**The Philadelphia Parking Authority
701 Market Street, Suite 5400
Philadelphia, PA 19106**

**Bid No. 25-16
Independence Mall Selective Repair and Renovations
Addendum One**

Design Drawings - Irrigation of the Living Wall

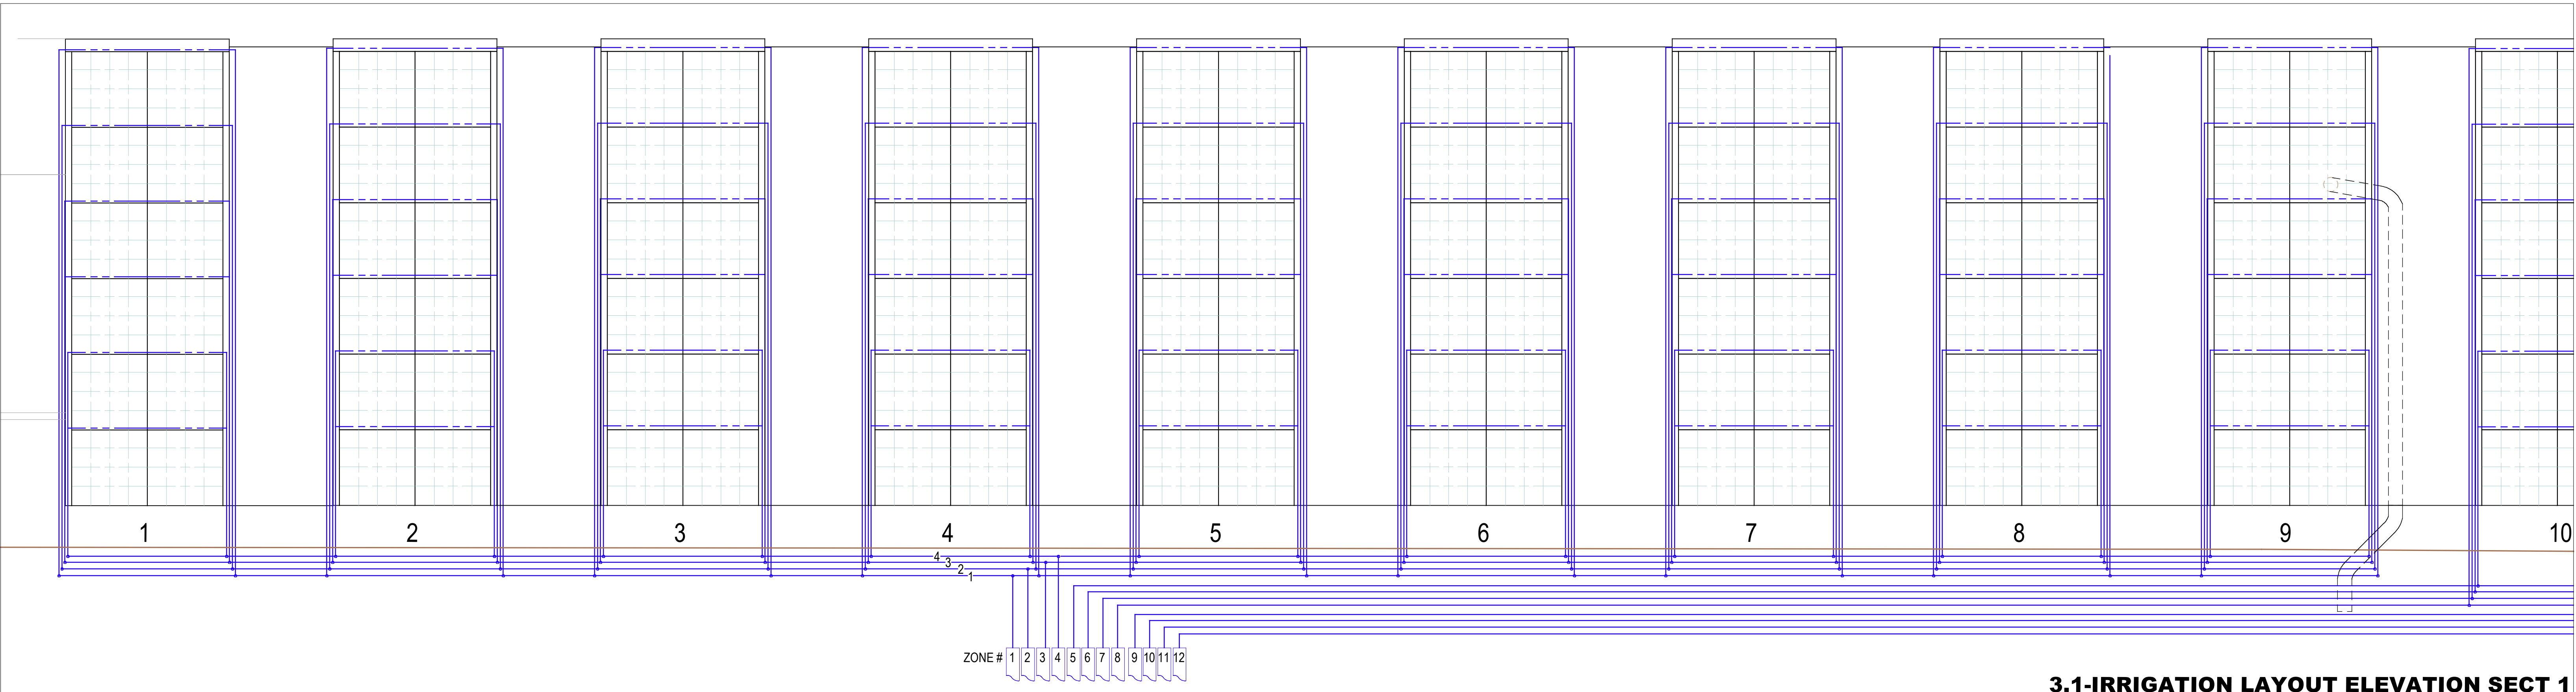
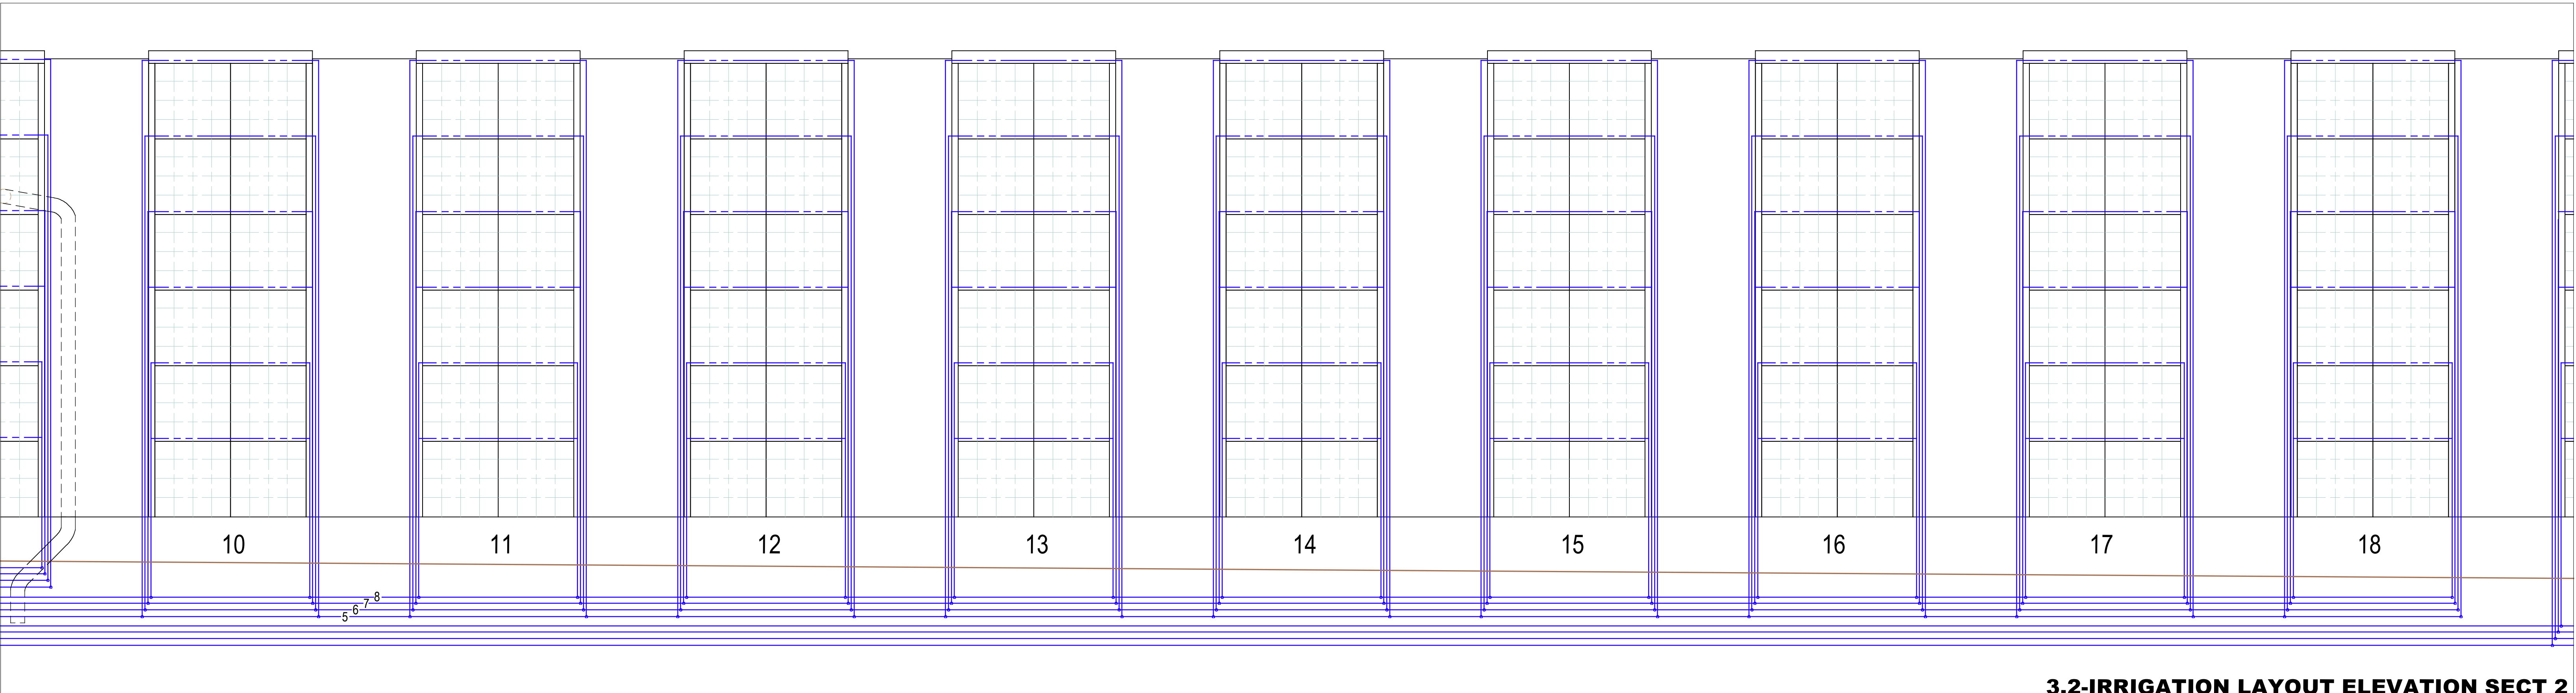
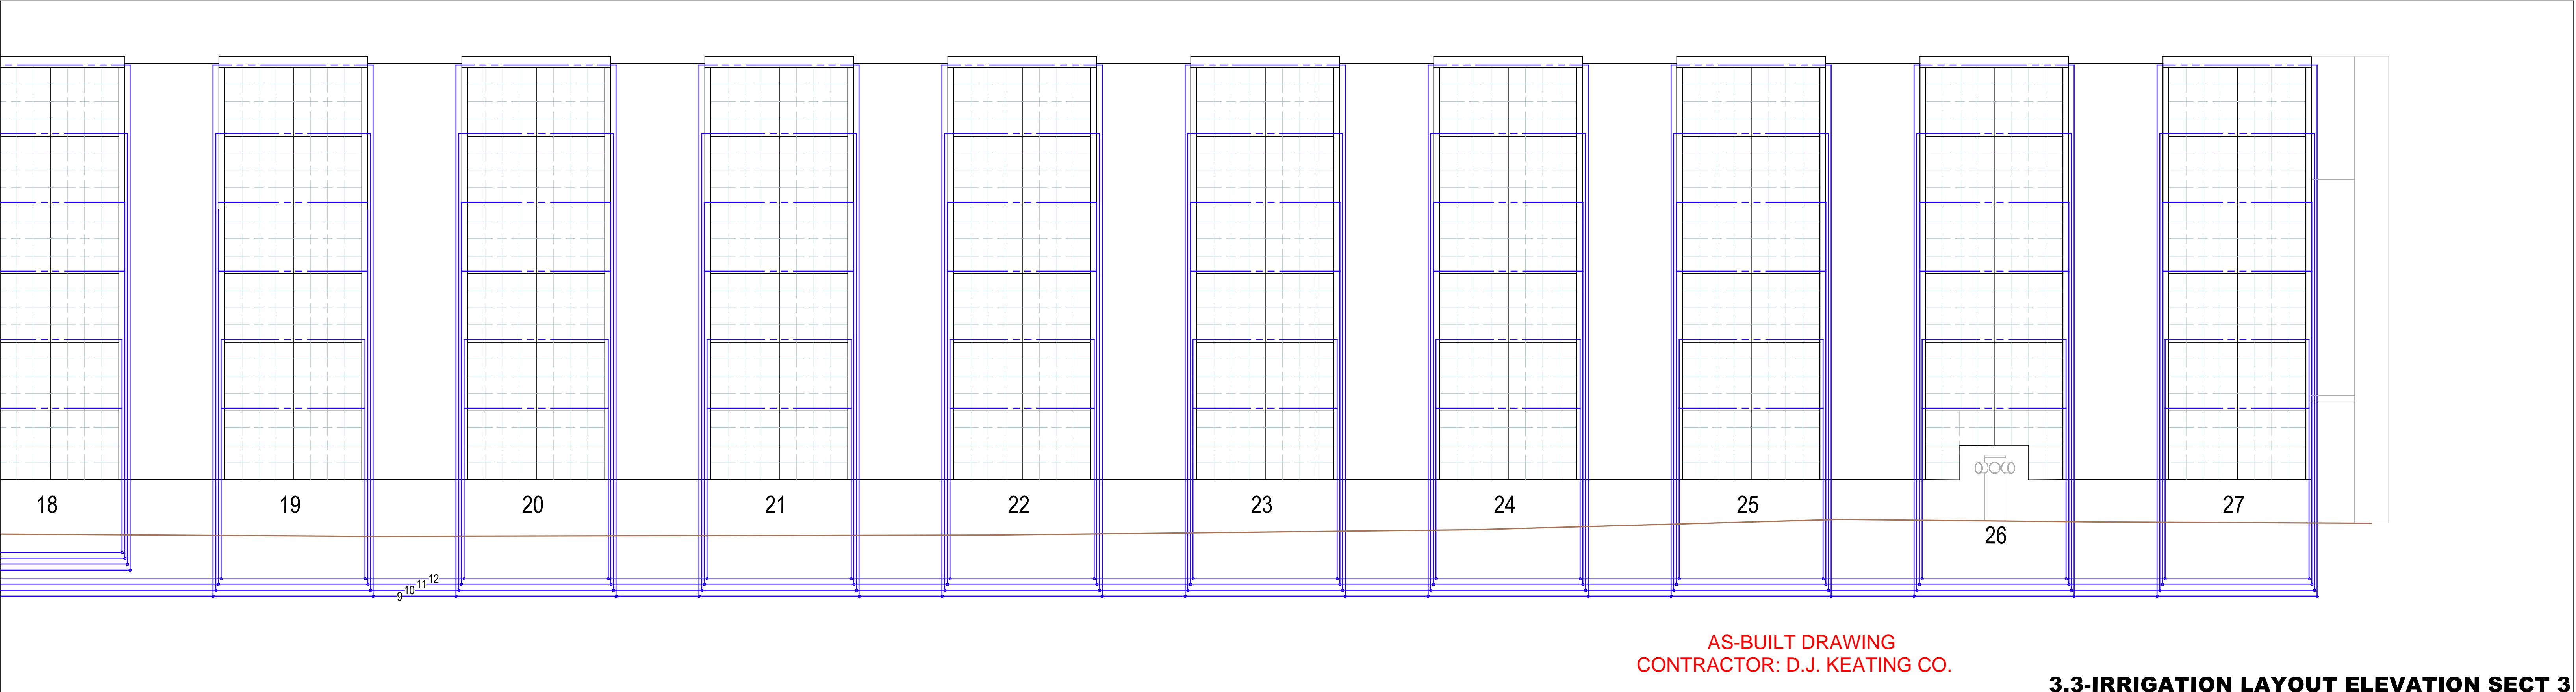
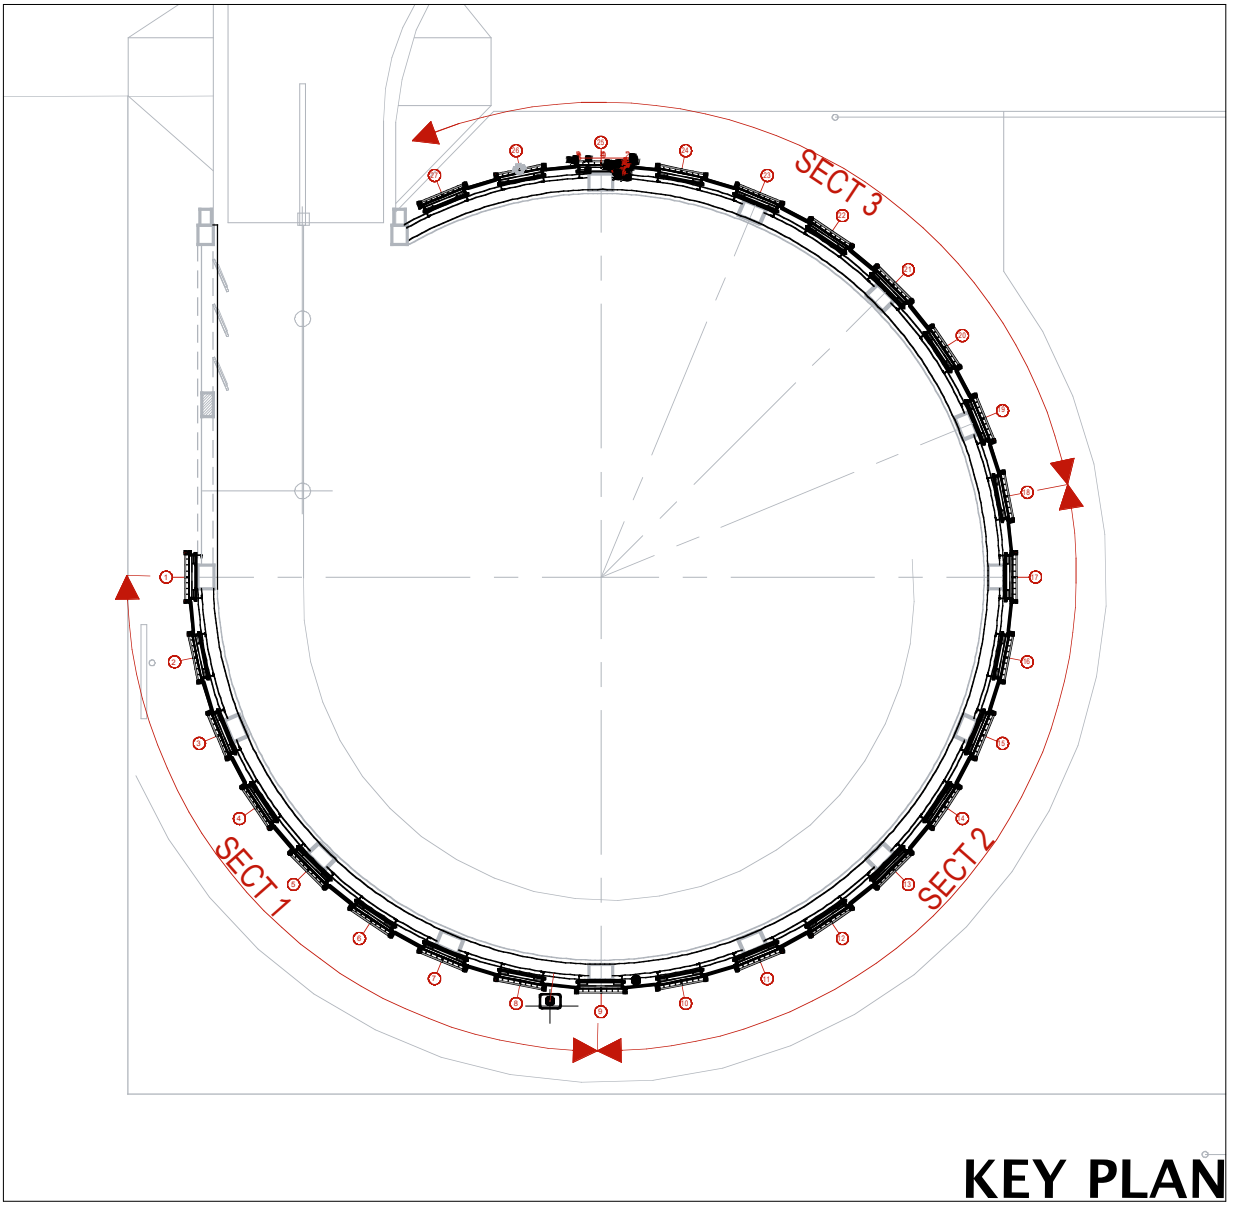
1. **Question:** Can you make available the original design drawings for the irrigation of the living wall? If As-built drawings are available, please send them as well.

4. **Question:** Will the irrigation be removed to access the excavation for the 6th and Arch Street helix leak remediation?

Response: There are original design drawings for the irrigation of the living wall. Please see Appendix A of this addendum.

Response: There is no requirement for the removal of the irrigation system for the waterproofing to occur. The irrigation box might need to be reset once the excavation is complete. If the existing piping is determined to need replacement, then the piping penetrating through the roof would need to be replaced prior to the

waterproofing. Replacement of the manifold and controller, if required and as seen in the equipment room, would not impact the waterproofing.
